**TENDER 16-20**

**WATER TREATMENT BUILDING**

**ADDENDUM NO. 5**

October 7<sup>th</sup>, 2016

TITLE: PROPOSED RAW WATER SUPPLY MAIN HIGHWAY #28 TREATMENT BUILDING - CONTRACT 2	DRAWING NO. 15-508- C103
SITE UTILITIES	PROJECT: 112311316
	REV. 2

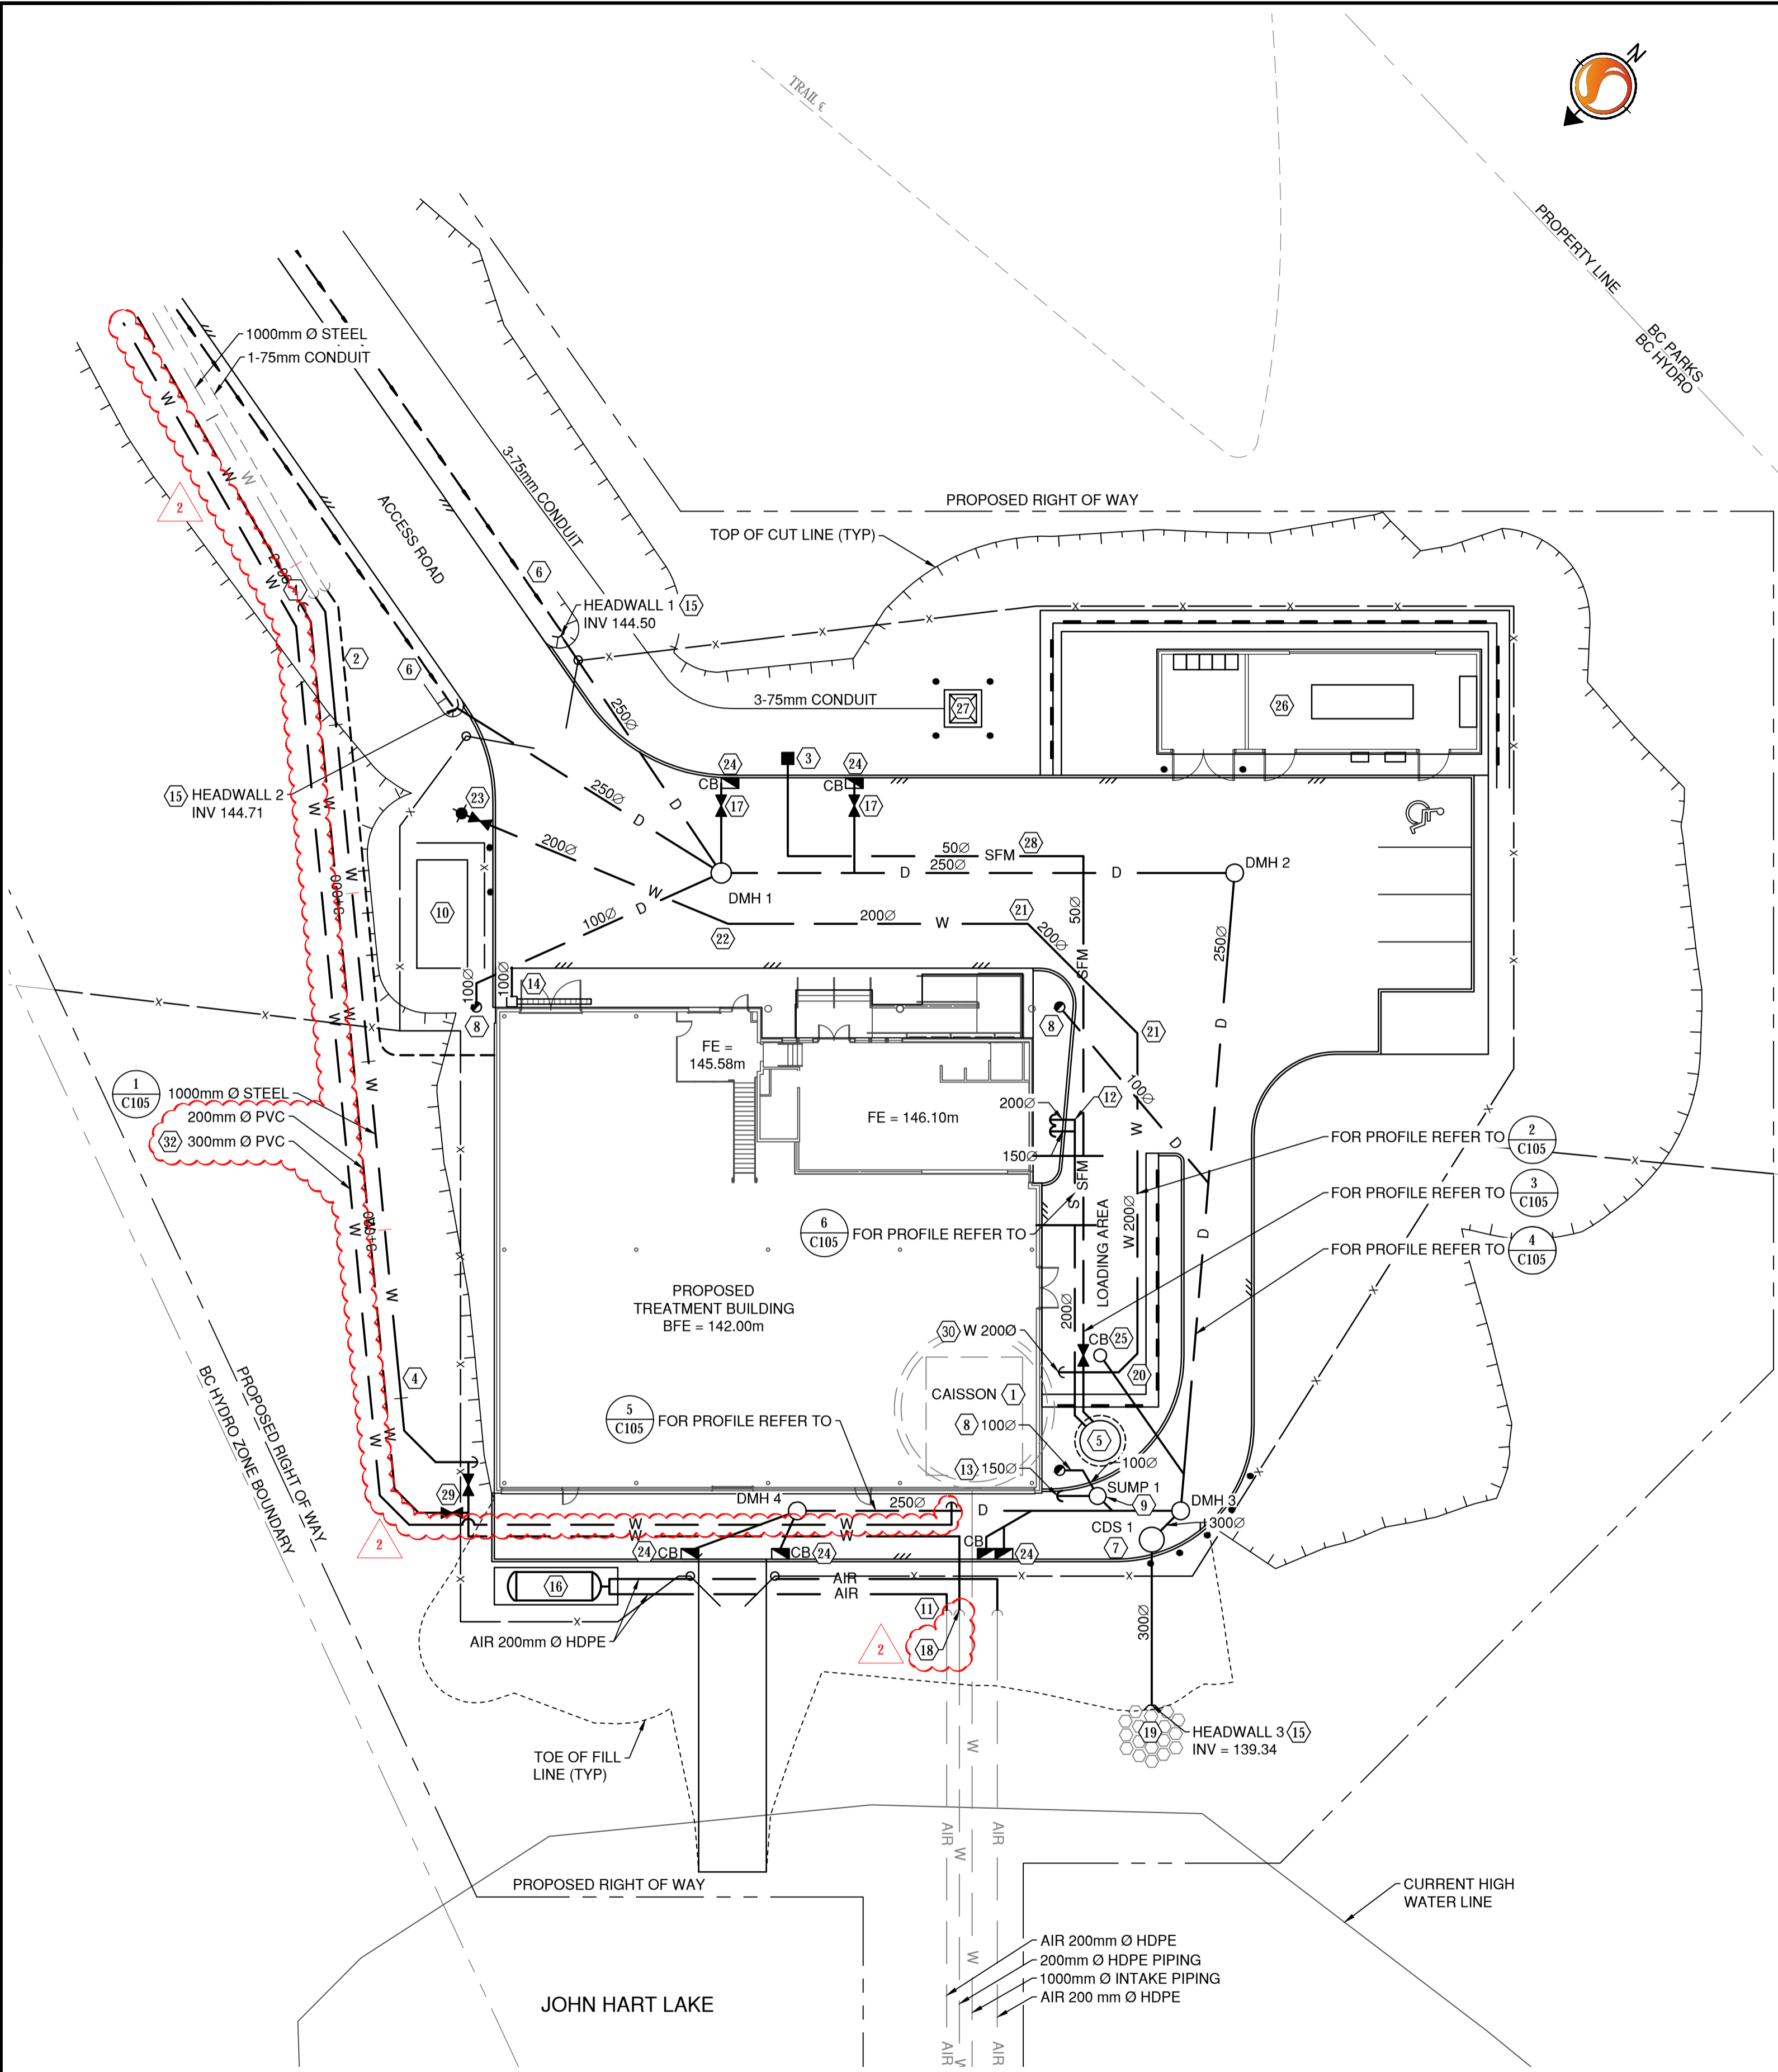
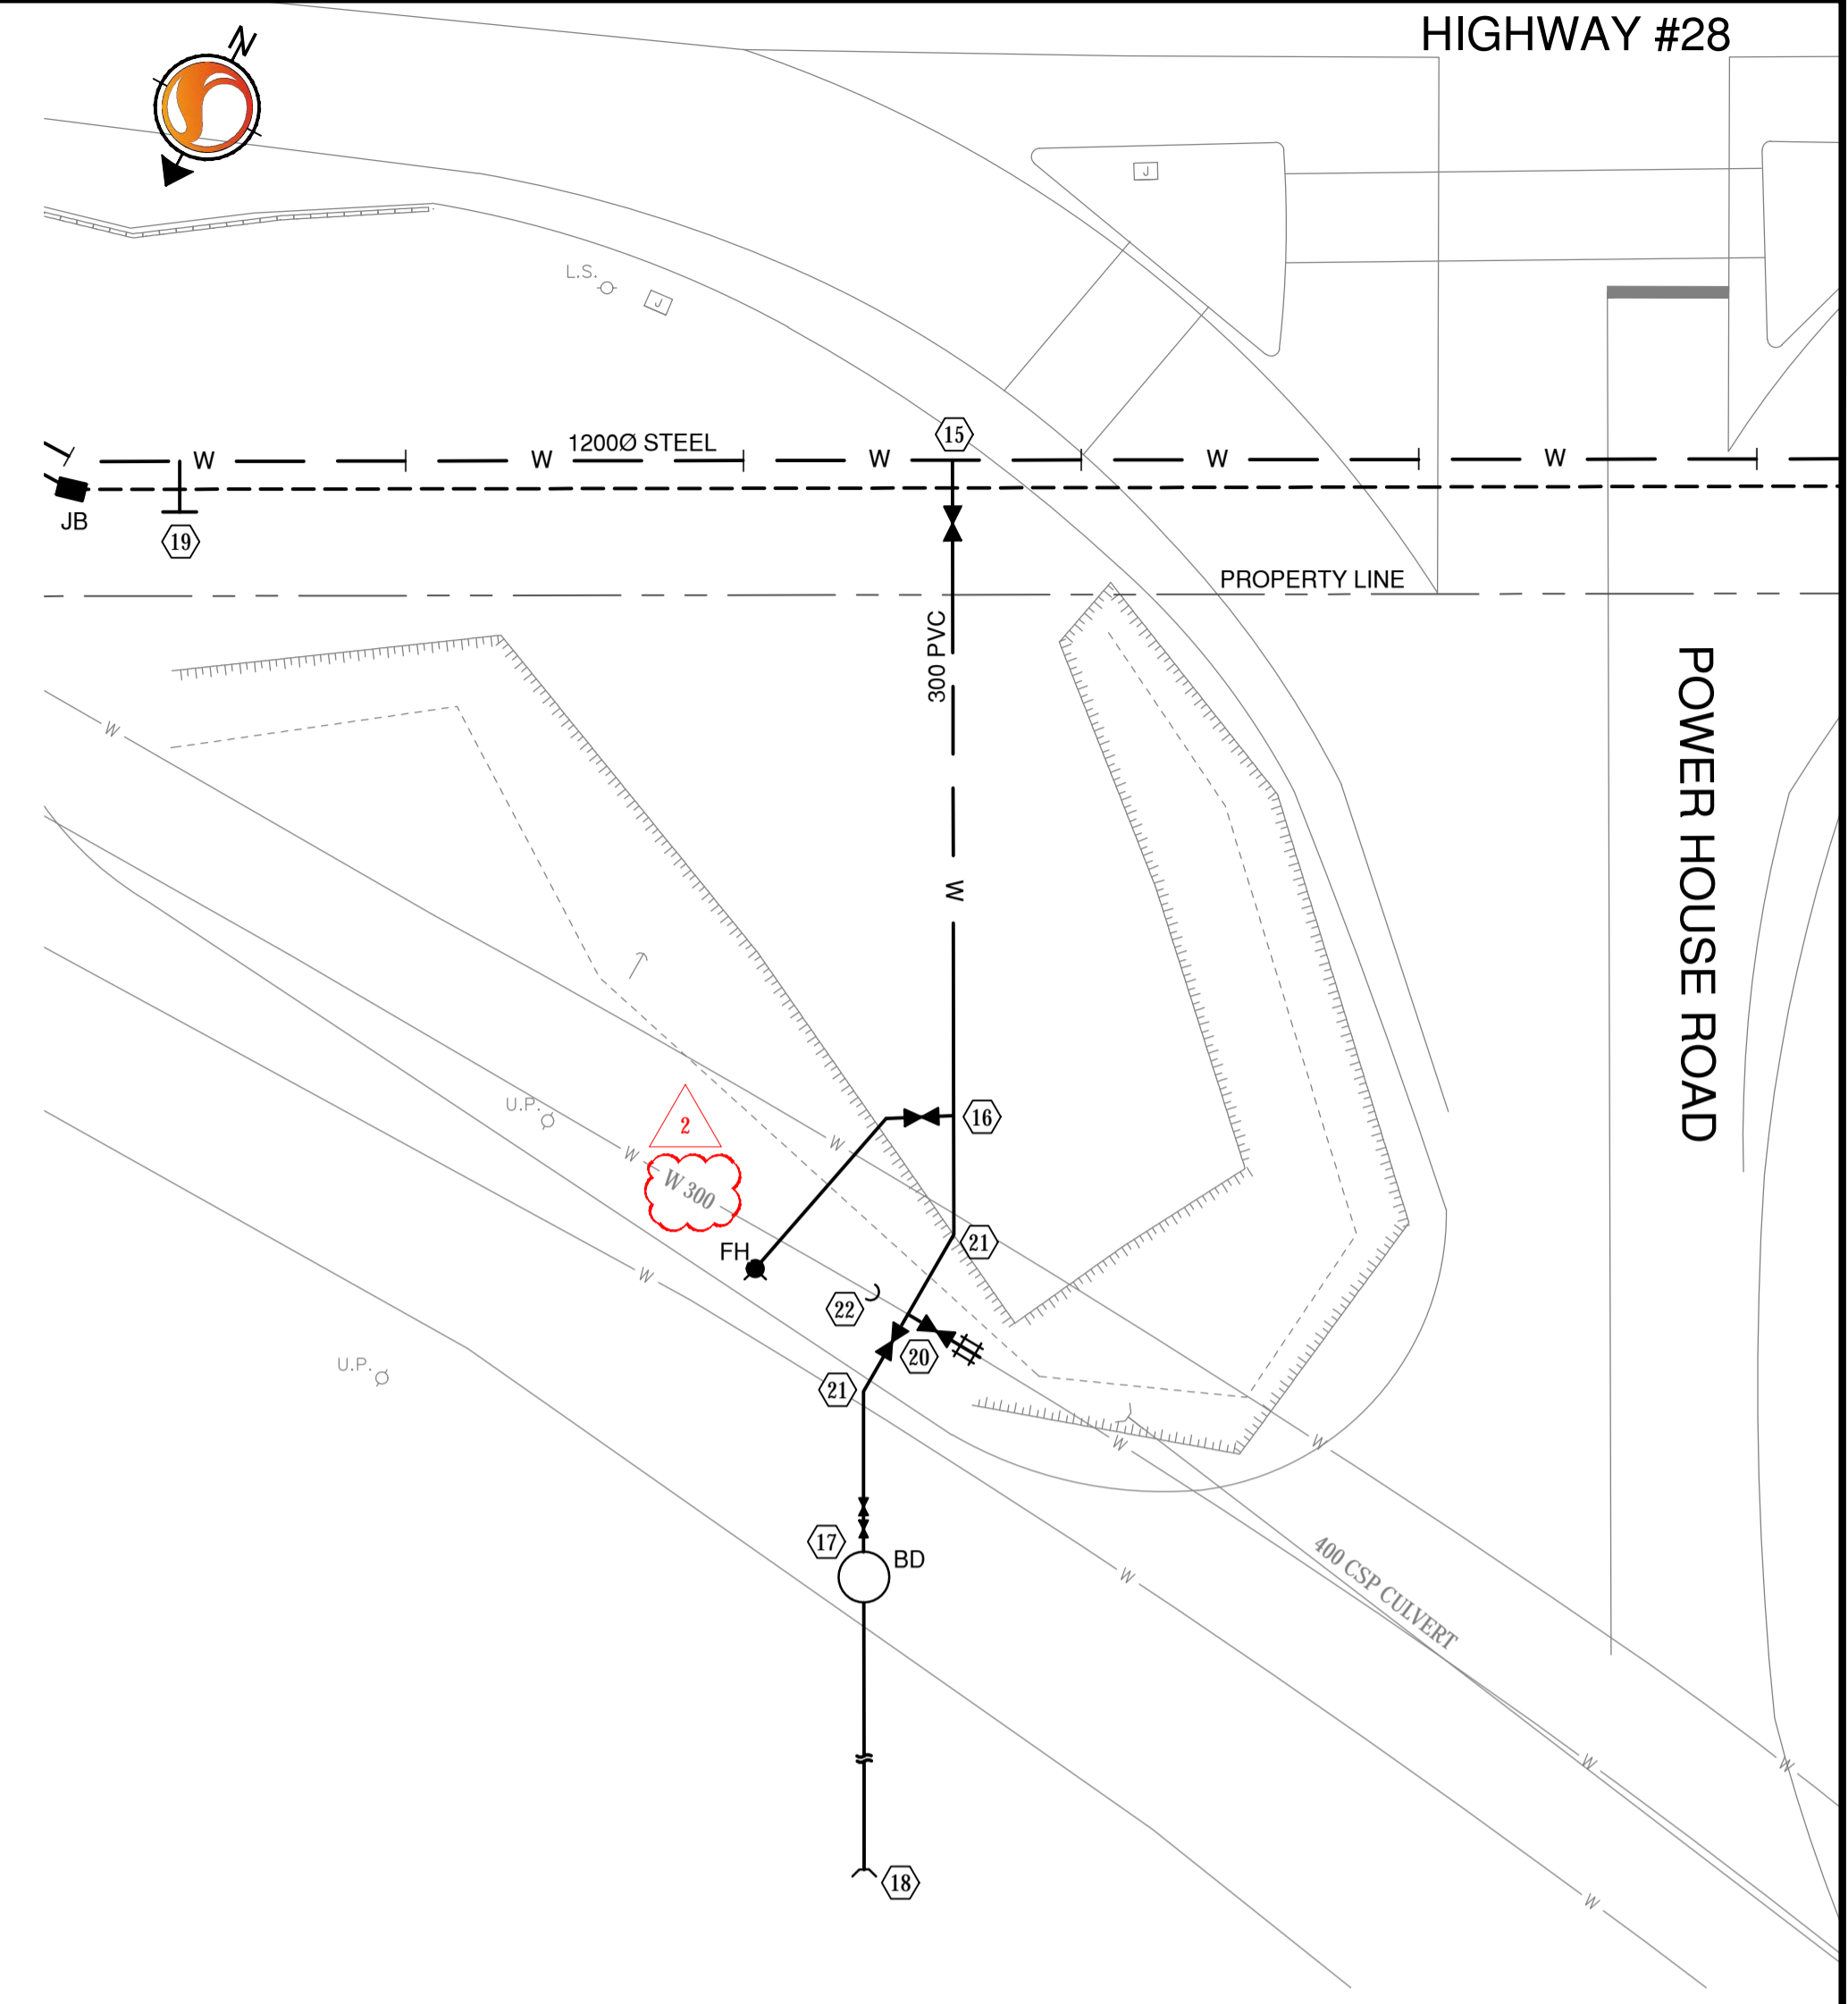
Pipe size – ‘TW’ process commodity – please confirm that the nominal pipe diameter is to be 1050mm. The continuation drawing (for the buried carbon steel pipe) on Sheet C103 indicates this line is to be 1000mm  $\Phi$  out in the yard. No reducer or expander is shown on the drawings in between the 1000/1050 mm transition point.

It was our understanding at the site visit that all site clearing had been completed and all remaining work would be carried out within the currently cleared area. It appears that the top of slope cut line indicated on drawing C103 could be beyond the tree line. Please provide the clearing and grubbing limits on a drawing or provide where the existing tree line is with respect to the top of slope, so that the area of clearing and grubbing can be calculated.

**Replace Clause 1.1.2.17 with** "Standby Generator, double-walled fuel tank shall be installed in a sound attenuated and weathertight E-House enclosure, access platforms as required and all accessories to be supplied by the Supplier. The equipment will be installed and commissioned by the Contractor. Allowance will be made to install a fuel tank on the exterior of the E-House, provided that additional space is not required; use the E-House footprint shown in drawing C103 – Site Utilities".
